BOTLEY WEST SOLAR FARM (EN010147)

Submission on behalf of Mr Dustin Dryden: [REDACTED]

Residential Visual Amenity, RVAA Deficiencies and the Requirement for a 250m Buffer

(In response to the Secretary of State's Request for Information dated 14 April 2026, as amended 28 April 2026 - paragraphs 26 - 29)

Project Title: **Goose Eye Curtilage**
 Description: **Buffer Zone Details**
 Location co-ord:
 Site address: **Botley West Solar Farm**
Oxfordshire

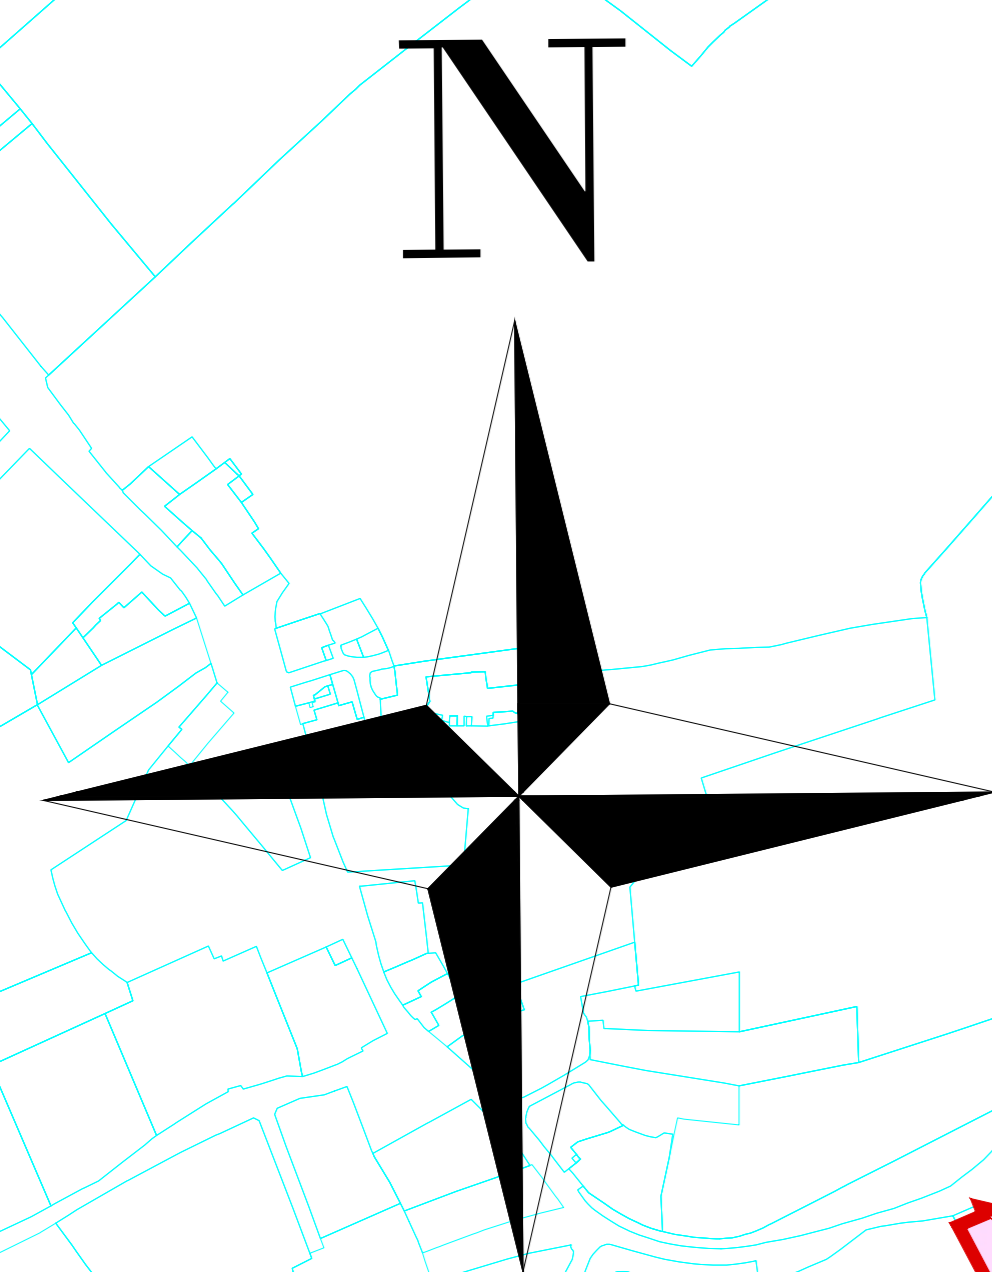
To assist consideration of this issue, a plan is attached showing Goose Eye Farm and an illustrative 250 metre offset from the farm curtilage. The plan demonstrates the practical implications of applying the separation distance identified by the Secretary of State and previously recommended during the Examination process.

The plan illustrates that the introduction of a 250 metre buffer would affect a number of surrounding development parcels and would require a consequential review of the layout of the scheme in the vicinity of Goose Eye Farm. This is significant because it demonstrates that residential visual amenity is not simply a matter of additional planting, screening or mitigation. Rather, it goes directly to the spatial design of the Proposed Development.

The plan also demonstrates that the issue is capable of objective assessment. If the Applicant maintains that a lesser separation distance would be sufficient, it should be required to demonstrate this through a robust, property-specific RVAA supported by clear evidence explaining why Goose Eye Farm should be treated differently from the approach contemplated by the Secretary of State.

The existence of a readily identifiable design solution further reinforces the conclusion that the current layout is not an inevitable consequence of the site constraints. It is the product of design choices which have prioritised development extent over the protection of residential amenity.

A minimum 250 metre buffer between the curtilage of Goose Eye Farm and any solar infrastructure is necessary to avoid unacceptable harm. If such separation cannot be achieved, the scheme would require material redesign.
